MODEL 163.154 #A as of 000001 up to 014254

P32.35-2001-01

Rear axle torsion bar

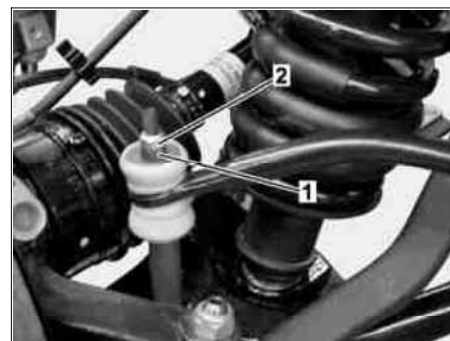
i Vehicles within the Effective Serial Number Range, must have the following work performed during next scheduled maintenance or service. Install pinch nut to ensure proper tightening torque of rear stabilizer bar mounting.

Installation		
1	Retorque nut (1) on rear stabilizer bar connecting rod bolt	Nm	*BA32.20-P-1001-04F
2	Install pinch nut (2) on top of previously torqued connecting rod bolt nut		
3	Counterhold connecting rod bolt nut (1) while torquing pinch nut (2)	Nm	*BA32.20-P-1003-04F
4	Repeat for opposite side

Number	Designation		Model 163
BA32.20-P-1001-04F	Nut, connecting rod to torsion bar	Nm	28
BA32.20-P-1003-04F	Pinch nut, connecting rod to torsion bar	Nm	28
